Re: Bayside Mixed-Use Development Project
Tax Lot 109.1-4-29
Town of Marlborough, Ulster County, NY
MC Project No. 05000787A

Based on the request of the Board at the August 19, 2019 Planning Board Public Hearing meeting regarding the above referenced project, Maser Consulting has prepared the below responses to those questions/concerns raised by the public and further requested by members of the Board. Some of these were provided in our July 3, 2019 submission to the Board, however additional detail has been provided as requested.

Commercial Loading Area Map

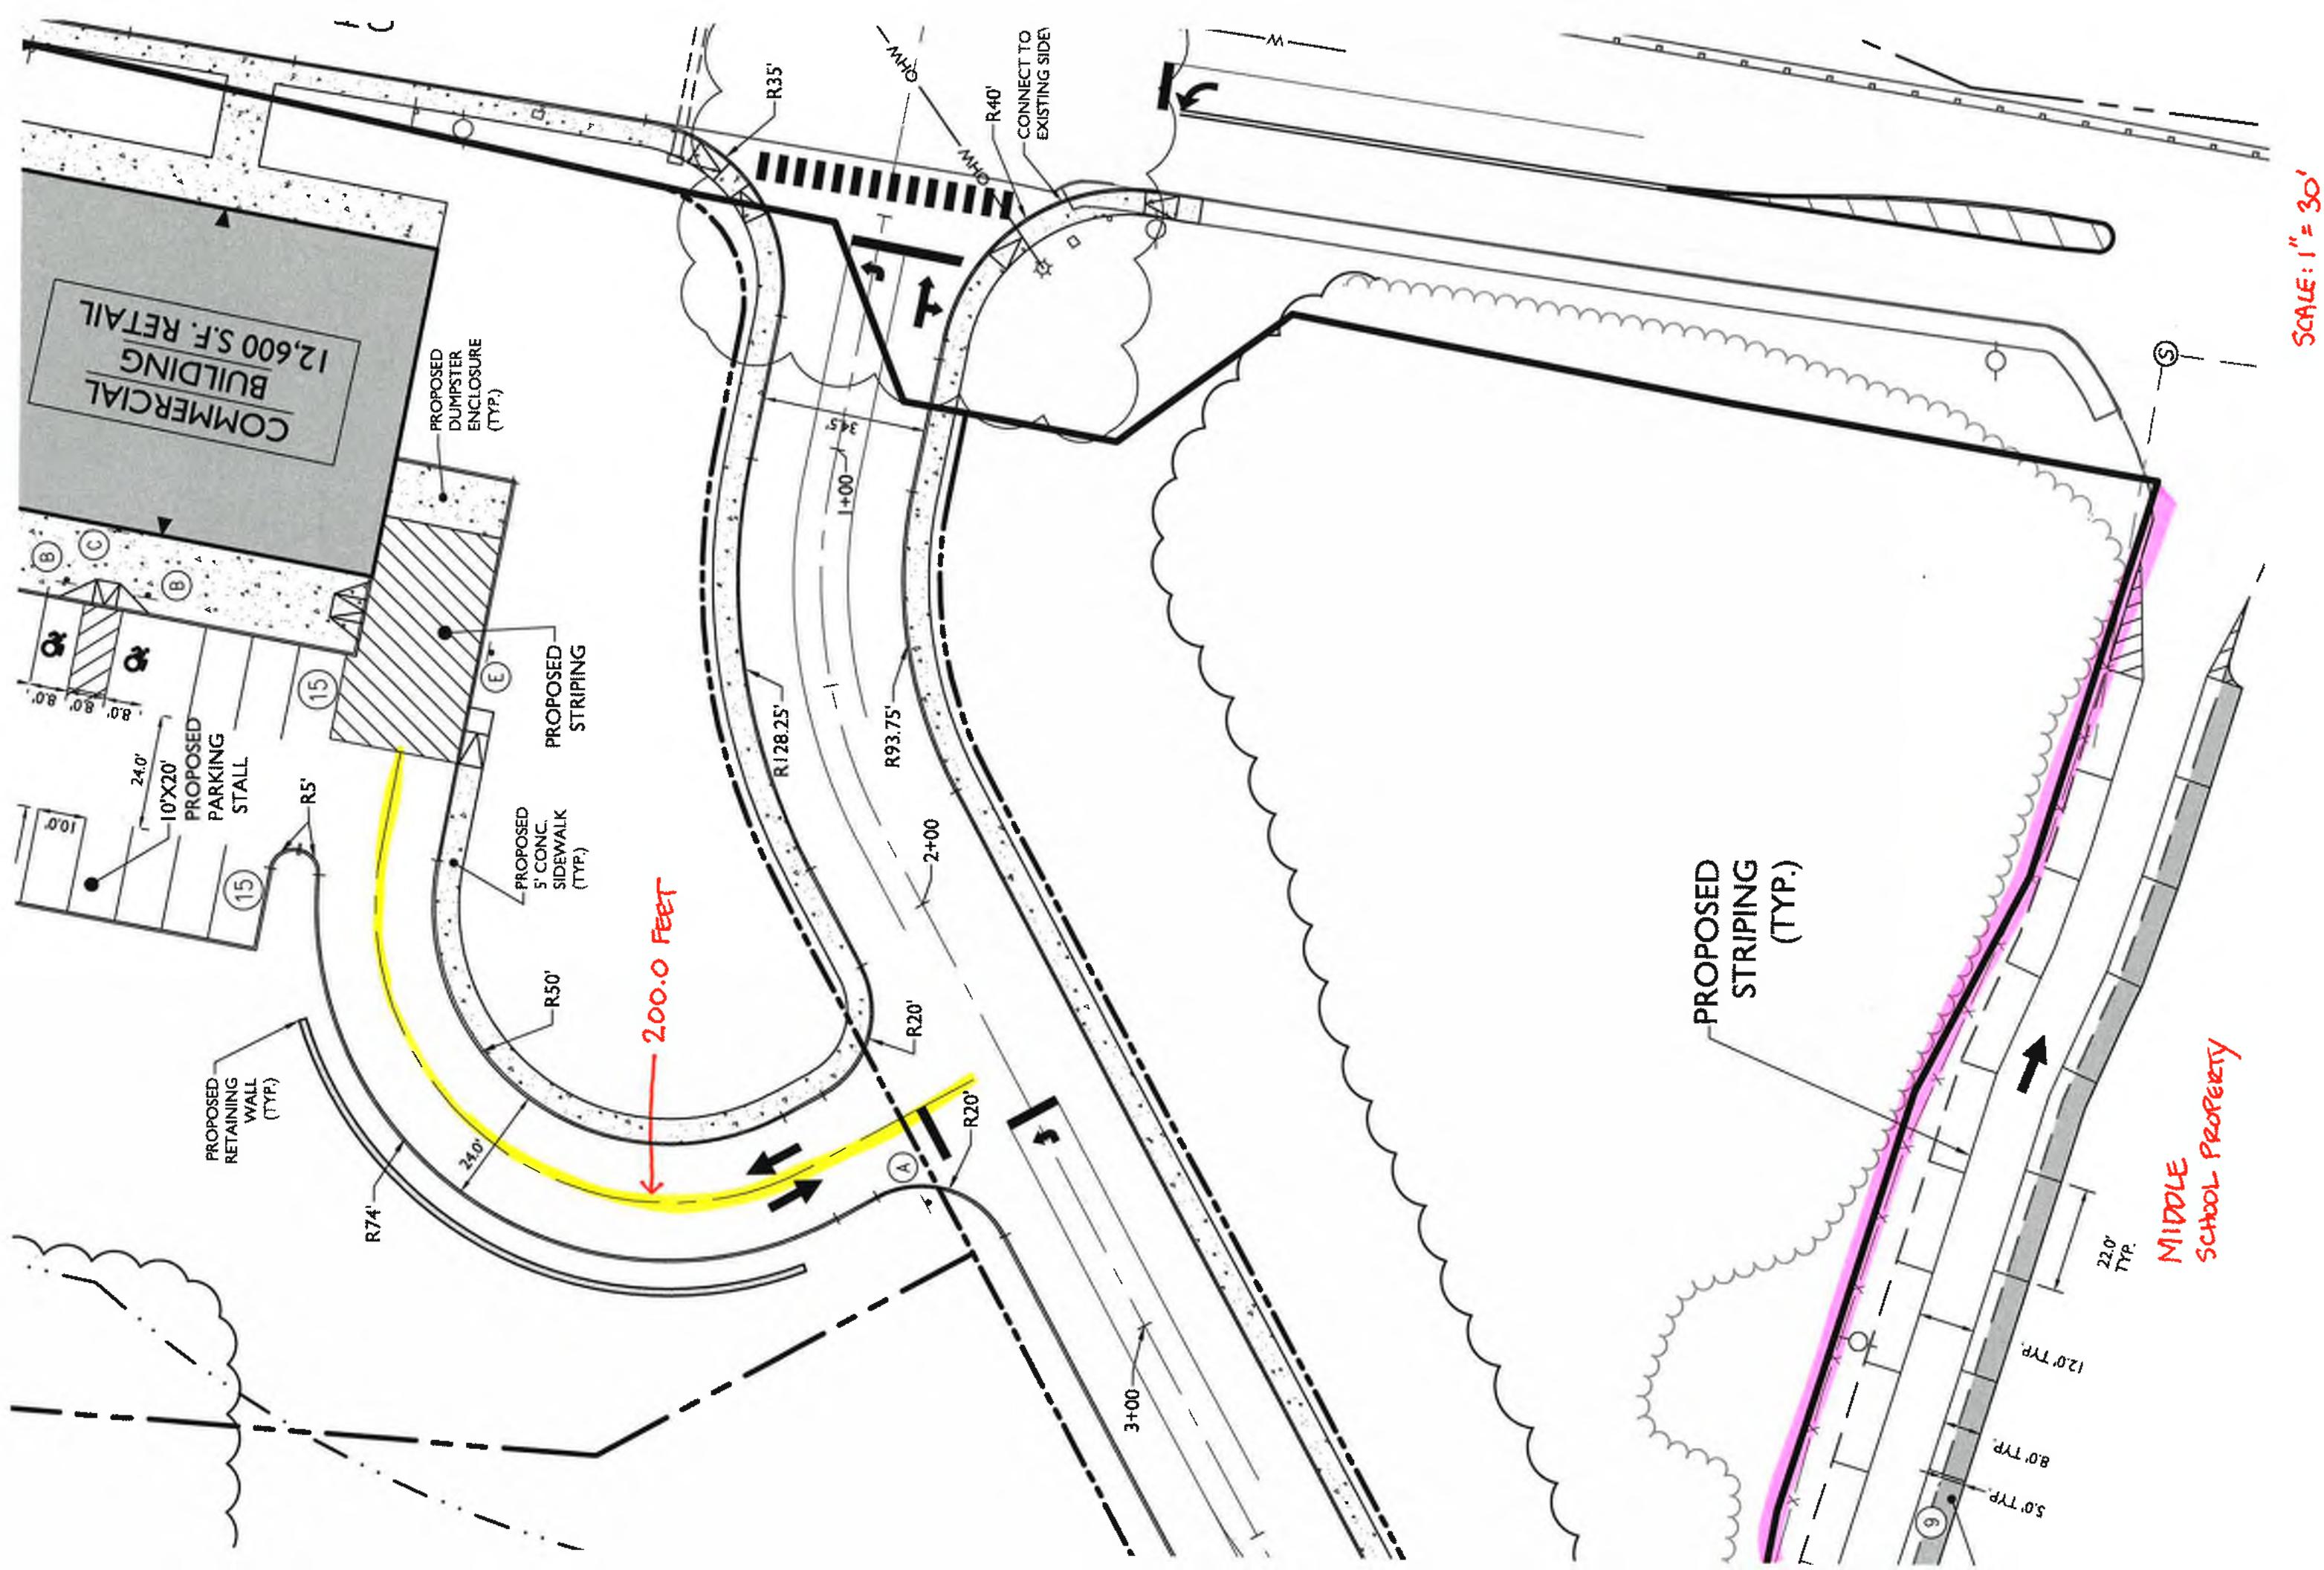
Comment #5: The public raised a question regarding the location of the proposed loading area and its proximity to the school and this potentially needing a zoning variance.

Response #5: Within §155-27 of the Town Code, it discusses the regulations and requirements for off-street loading. This includes permitted locations for the proposed 'access to roads' (see section §155-27.B.4.) for off-street loading areas. Within this section it states, "...There shall be no access within 200 feet of any school, playground or church,..." From the proposed loading area, along the driveway to the same is 200 feet (see attached map). The adjacent school property to the south (Middle School) or east (Elementary School) is additionally greater than 200 feet from that point. However, it should be noted that this proposed commercial lot of the project is proposed to be a part of the BC (Business Corridor) Overlay District and Code Section §155-12.H.4 for that district states:
